Marulan South Limestone Mine Continued Operations State Significant Development Application

RESPONSE TO SUBMISSIONS

Prepared for Boral Cement Limited | September 2019

The public authority submissions are addressed in this chapter. **Bold** text is an exact reproduction of the submissions received, while normal text is Boral's response to submissions.

Figure 5.1 Annual extraction probability ranges for Marulan Creek dam (Figure 7.2 Advisian 2018)

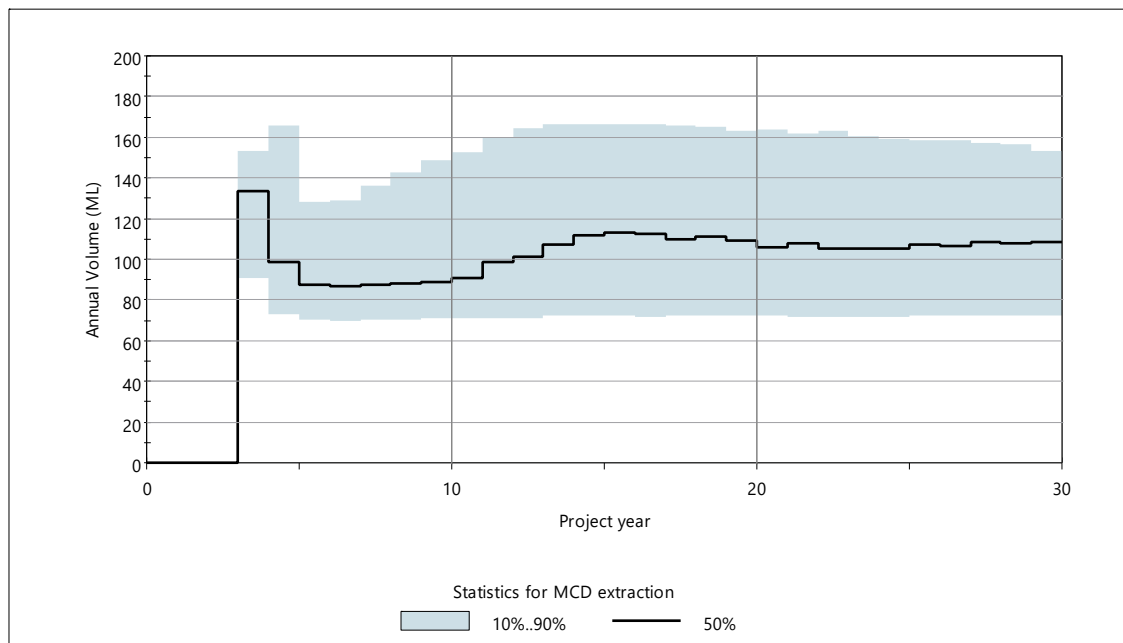
Potential direct impacts on the continued availability of local water resources, particularly the Tallong Dam, are of significant concern to the community. Community submissions have also raised concerns regarding associated indirect impacts on biodiversity, local amenity and recreation, and availability of water supplies for firefighting. The Department requests a detailed response to each of these concerns. This response should include a clear comparison between Boral's existing water usage from Tallong Dam and proposed water usage under SSD-7009, throughout the various stages of proposed mining.

As shown in Figure 5.1, Marulan Creek dam is anticipated to have sufficient water volume to start supplying the mine around three years after the dam is built. The dam will be required to meet mine water demands when the sediment basins and on-site mine water storage dams do not contain sufficient water to meet demand.

Figure 6.5
Replacement monitoring bore area

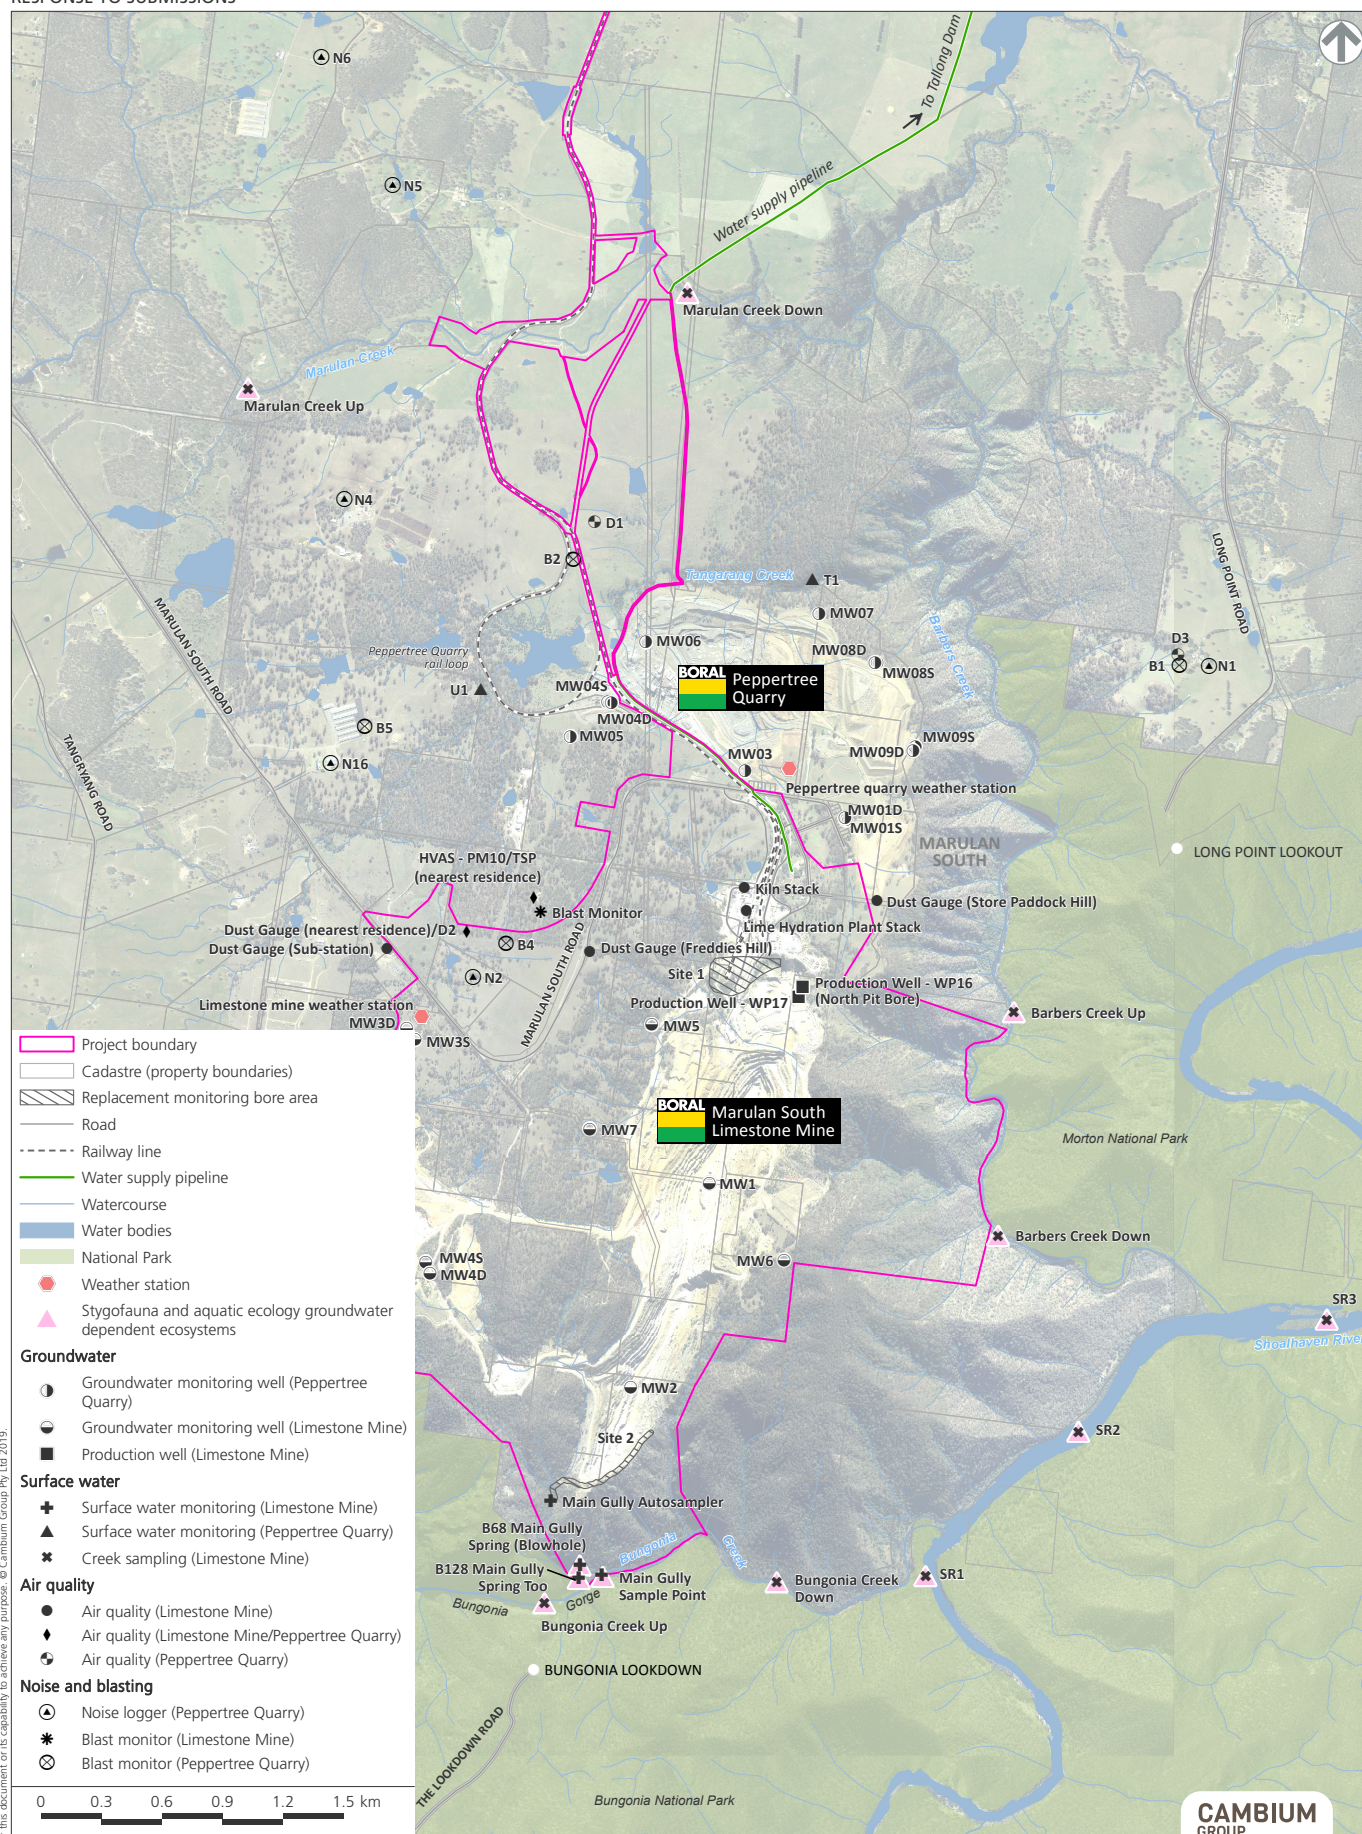
- a. a new water pollutant monitoring point be established to replace WP16;**
- b. additional groundwater monitoring bores be established to offset the loss of MW1 and MW2, preferably prior to removal of the existing bores;**
- c. further assessment be undertaken with respect to bicarbonate alkalinity, total suspended solids and settling agents in order to determine appropriate discharge limits; and**
- d. any future surface water monitoring program include analysis of metals, including aluminium and chromium, bicarbonate alkalinity and settling agents. Please provide a response to the EPA's proposals in the RTS.**

A new groundwater bore will be installed to replace bores WP16 and WP17 for the purpose of monitoring groundwater level and water quality. This bore will be in the area identified as Site 1 and shown in Figure 6.5. This area is near bores WP16 and WP17, is immediately downgradient of the main mine processing plant, and outside of the pit expansion footprint in this part of the mine development area.

Similar for bores WP16 and WP17, a new (single) groundwater bore will be installed downgradient of the pit void to replace bores MW1 and MW2. The best available options for siting a replacement monitoring bore is in the area identified as Site 2 and shown in Figure 6.5, which includes the following area:

The location for the MW1/MW2 replacement monitoring bore will be confirmed in consultation with the EPA and will be determined during preparation of the groundwater monitoring and management plan, as part of the overarching water management plan for the mine.

Figure 6.6 Running 31-day average normalised PM and $PM_{2.5}/PM_{10}$ ratios for Muswellbrook

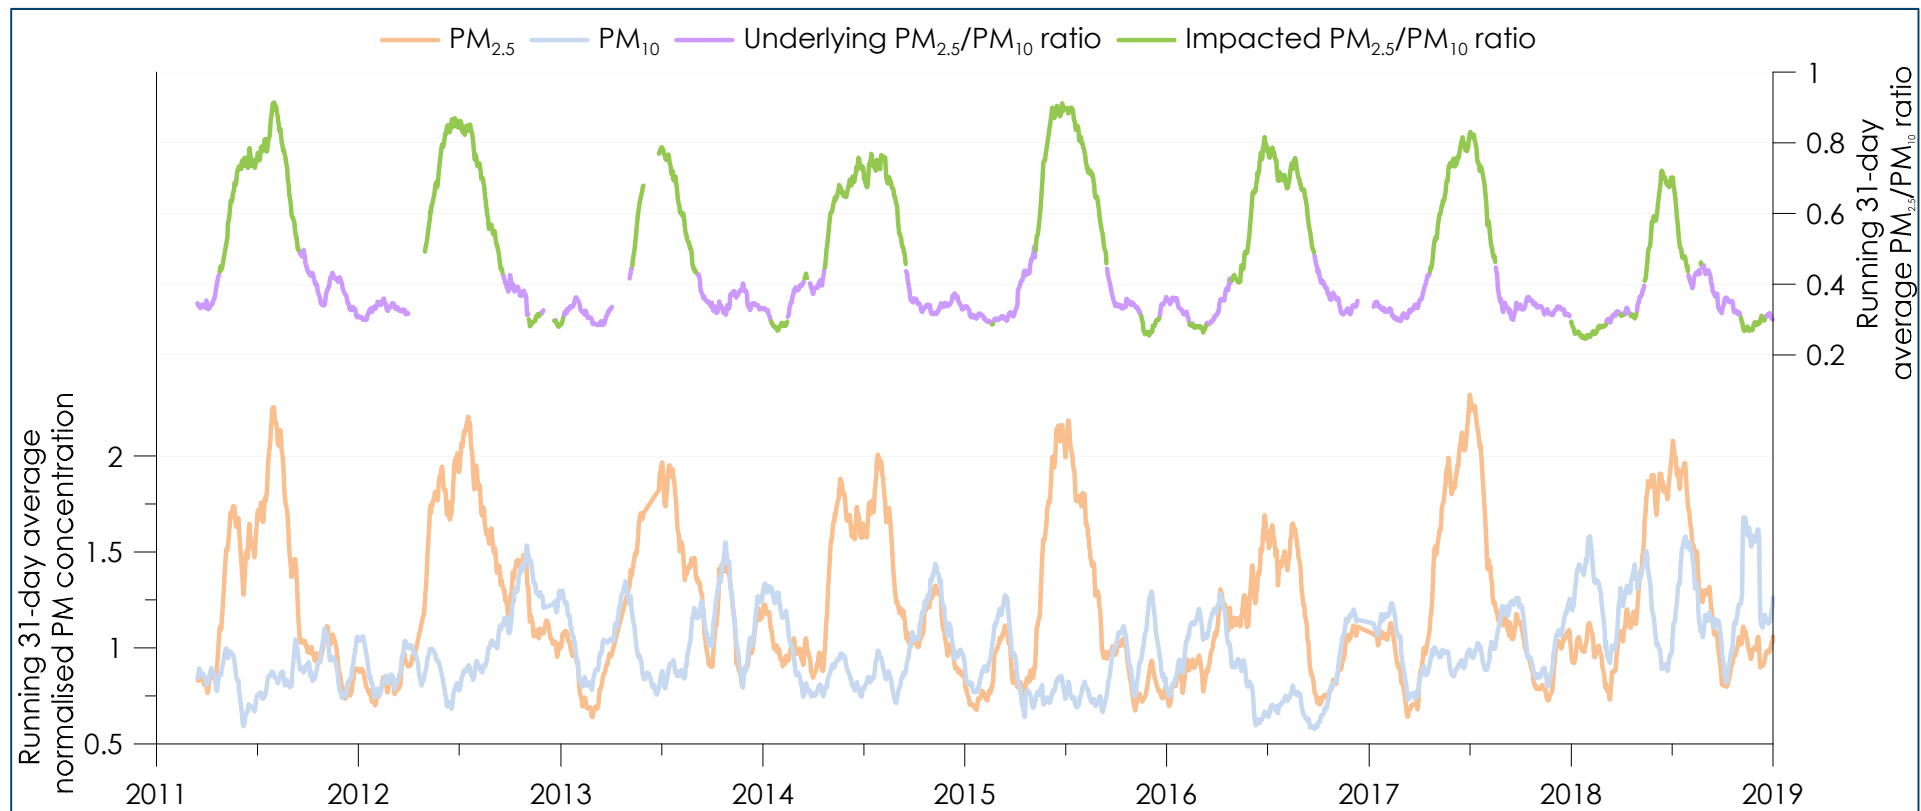
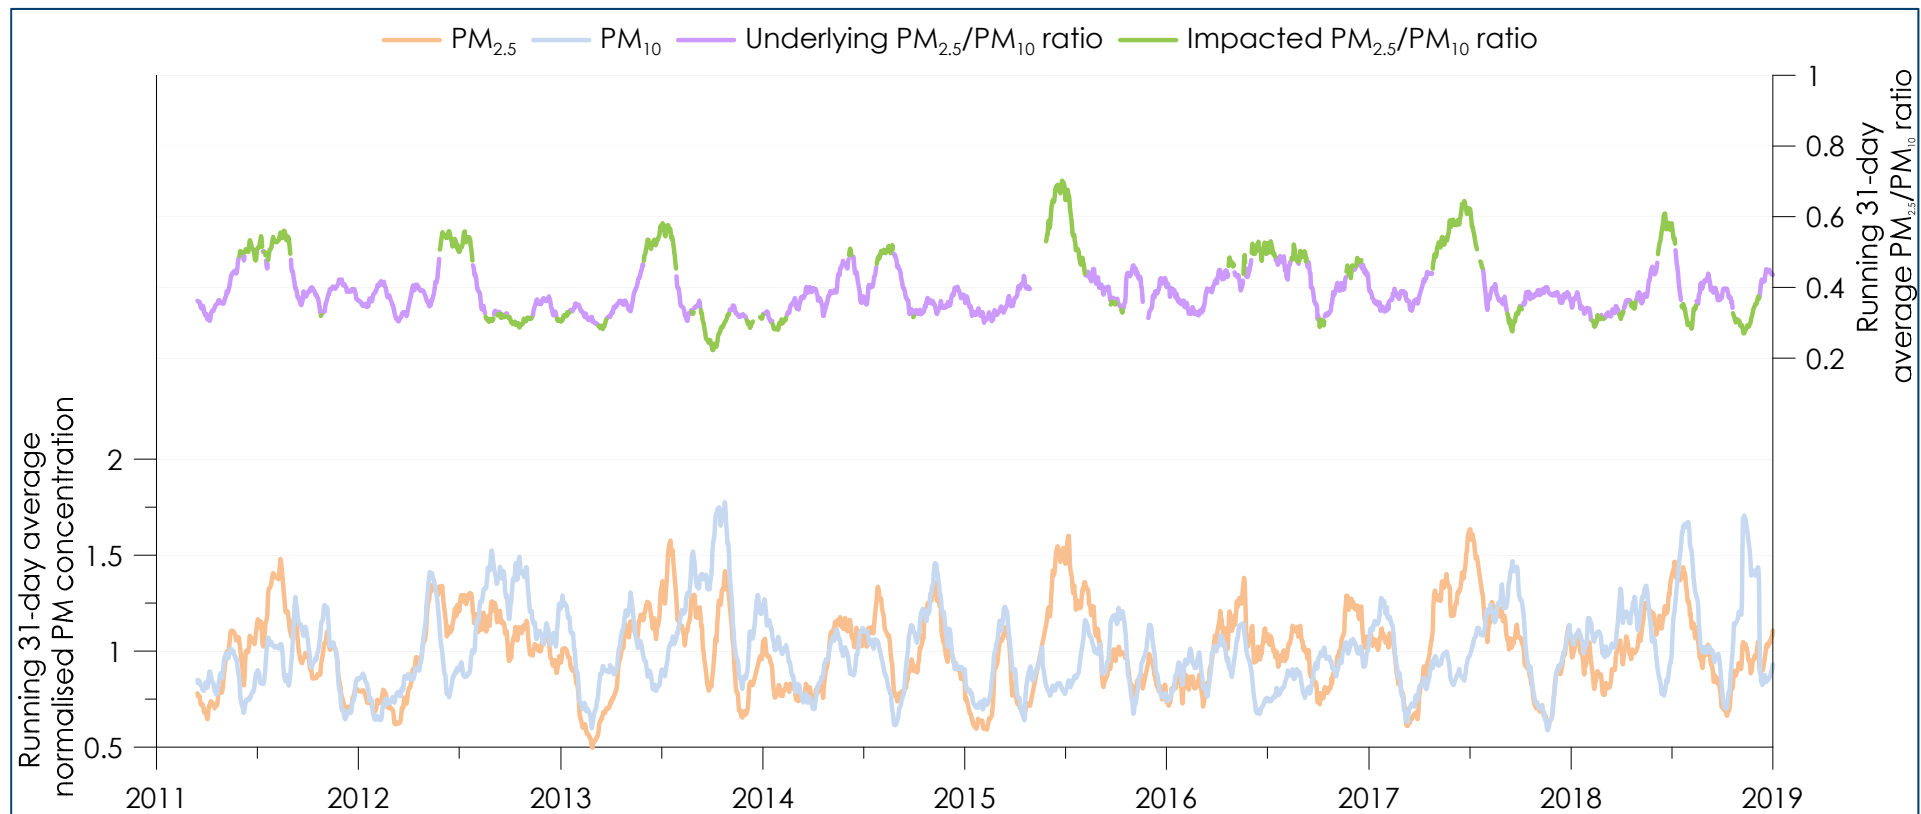
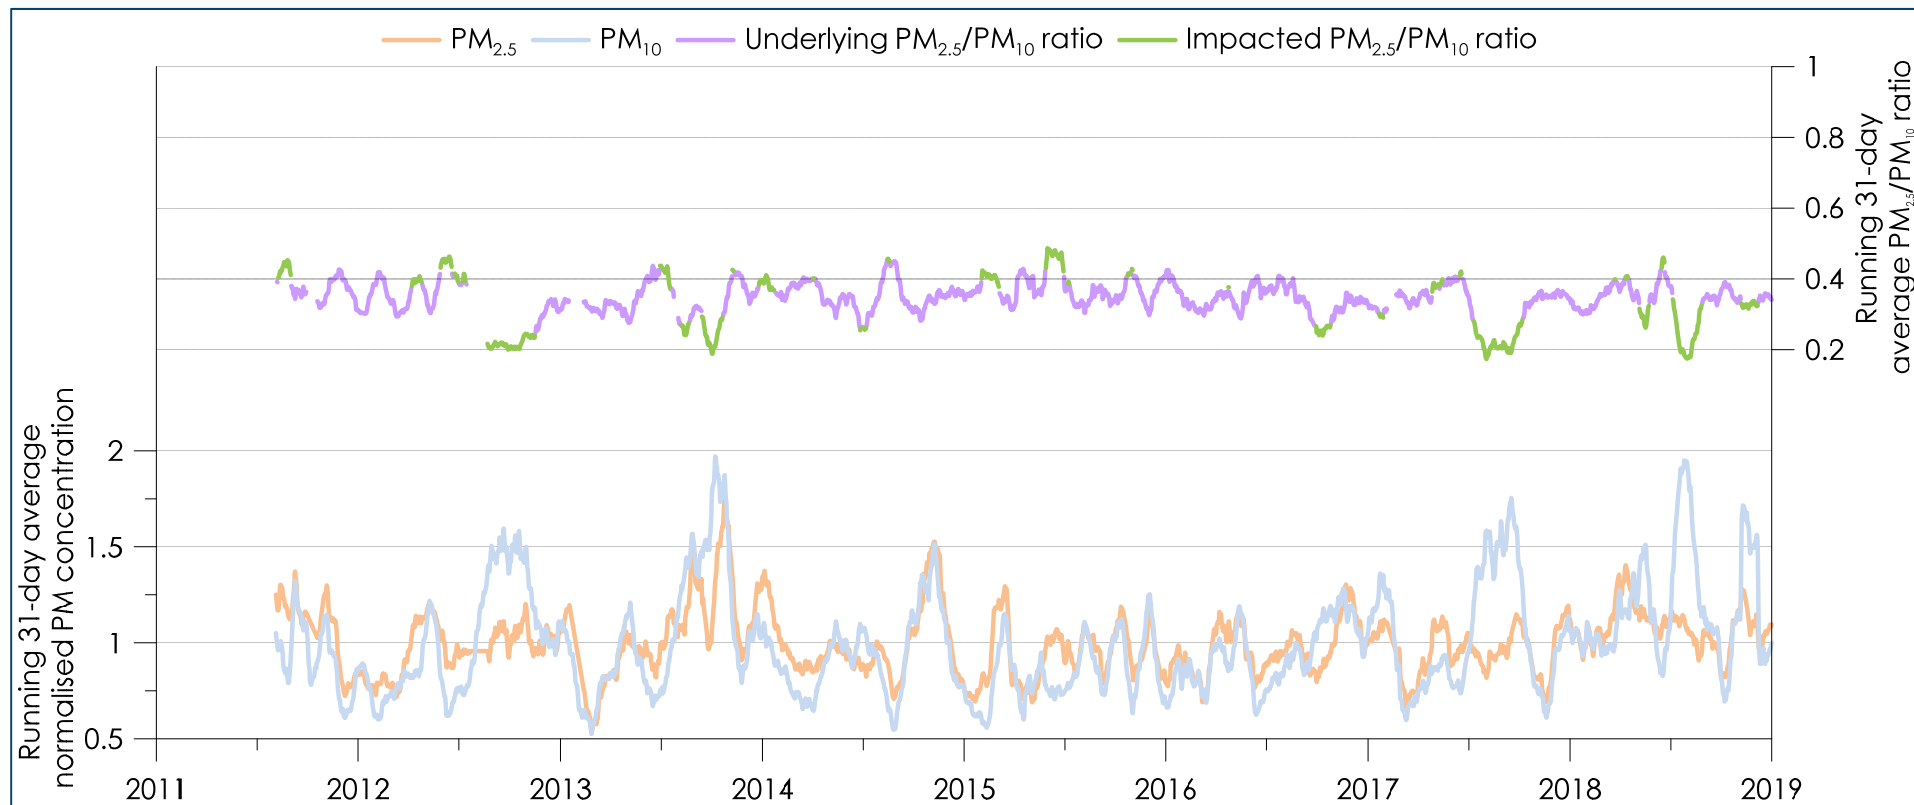
The ratio of the 24-hour criteria ($25/50 = 0.5$) that EPA raises was considered. The highest 24-hr PM_{10} and $PM_{2.5}$ levels are unlikely to occur at the same time, and thus the ratio is not 'valid'. Additionally, this ratio would be unrealistic for this project as it could only occur in situations where sources of $PM_{2.5}$ are a very dominant influence, as may occur in large rural towns in cooler climates. Examination of the available data indicates that the 24-hour average criteria ratio cannot reasonably be applied to represent the likely conditions surrounding the mine as there is no major such source of $PM_{2.5}$.

The table and figures show that the underlying ratio of PM_{2.5} to PM₁₀ is consistent between all three sites (indicated by the purple line in Figure 6.6 to Figure 6.8). However, there is large variation between the impacted ratios at the three sites (the green line in Figure 6.6 to Figure 6.8). The higher impacted ratios at Muswellbrook and Singleton indicate that these sites are largely affected by sources of PM_{2.5}, which has been proven by CSIRO and ANSTO studies to be primarily due to smoke from residential wood heaters in winter.

We also note that the modelling predictions have been tested with the application of the average underlying ratio in the Hunter Valley of 0.36 to the assessment instead of 0.32, and as a result does not change the outcomes of the assessment.

Figure 6.9 Marulan Creek flow duration curves for a 30-year climate period

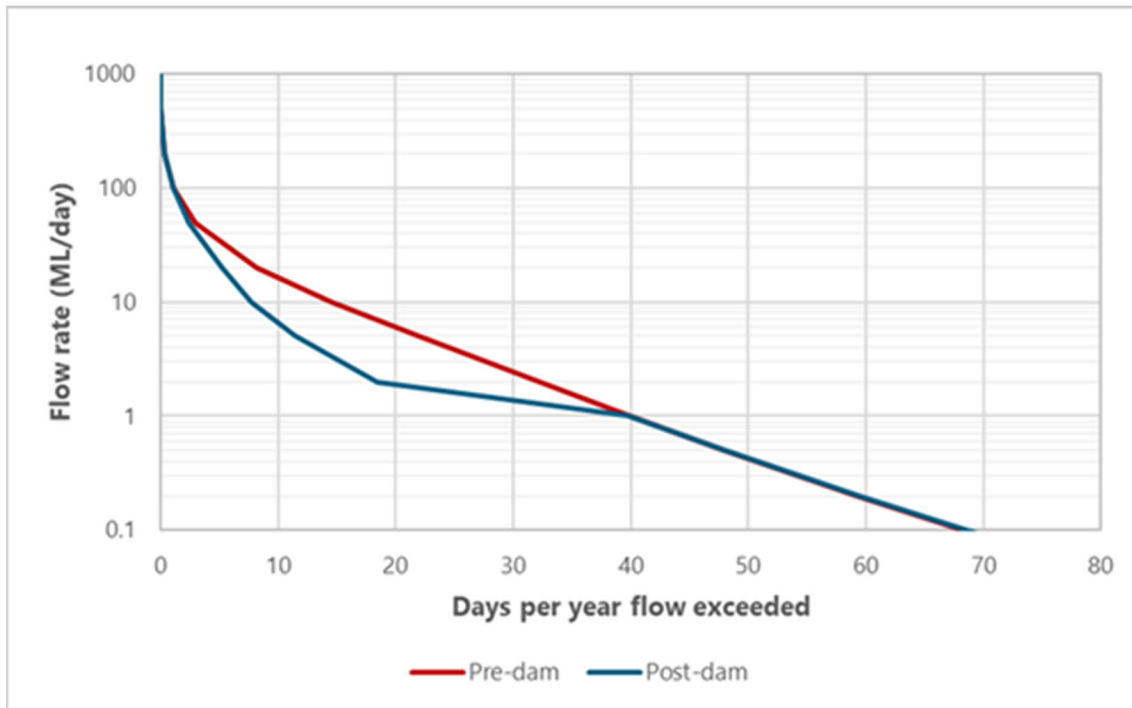
Section 9.3 of the Surface Water Assessment states that as 'there are no downstream users, licensed extraction of water from Marulan Creek Dam would not have any impact on other users. Please provide further explanation for this conclusion, given that the proposed dam would be located within the wider Barbers Creek Management Zone, which ultimately forms part of the Sydney Drinking Water Catchment.

Water balance modelling shows that the Marulan Creek dam will provide an average supply of 98 ML/year, while maintaining downstream flow of 829 ML/year. The modelled flow duration with the Marulan Creek dam is shown in Figure 6.9 (surface water assessment Figure 8.2) compared to the pre-dam conditions.

Riparian releases from the dam mean that low flows (<1 ML/day) and high flows (>30 ML/day) will be unchanged. Mid-range flows will be maintained, however with reduced volume.
